REPORT TO THE CALGARY PLANNING COMMISSION

DEVELOPMENT PERMIT	ITEM NO: 03	
	FILE NO:	DP2008-4275
	CPC DATE:	2013 June 20

PROPOSAL:
10 Storey Office Development, At-Grade Retail

LANDSCAPE SITE PLAN

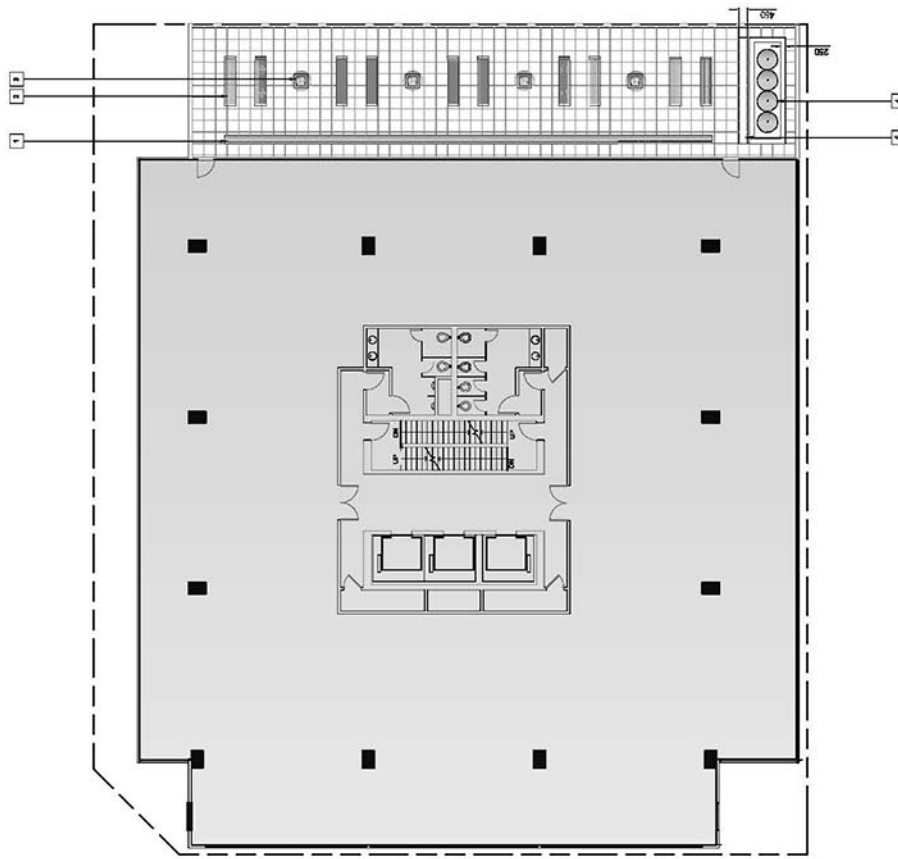
- d. Amend all relevant plans (landscape plan, etc.) to clearly display what treatments are being proposed in the City right-of-way VS. the private development site. The current Landscape Plan "Surfacing Legend" does not clearly represent / match what is currently shown on the Landscape Plan. Ensure that the treatments are broom finish City standard concrete with "tooled joints" within all portions of the City right-of-way; where new treatments are proposed.

1 GRADE BEAM LAYOUT AT EDGE OF TREE GRATE
SCALE 1:25

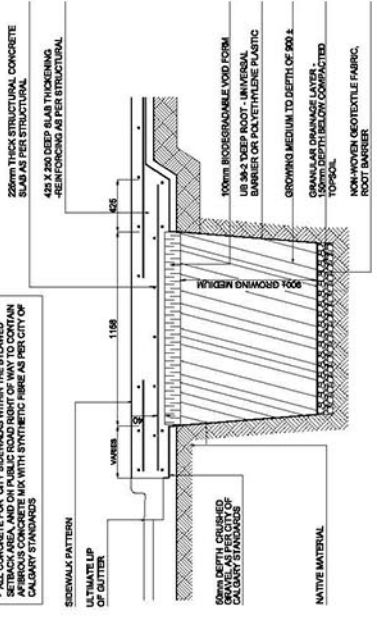
- e. Provide tree trench details. All tree grates to be rectangular, a minimum of 1.2 meters X 1.83 meters. The City standard is cast iron "sunburst" design. Alternative grates would be considered with approval from Roads if the developer executes a perpetual maintenance agreement. **Contact the Design Technician, Roads at 403-268-3801 for details.**
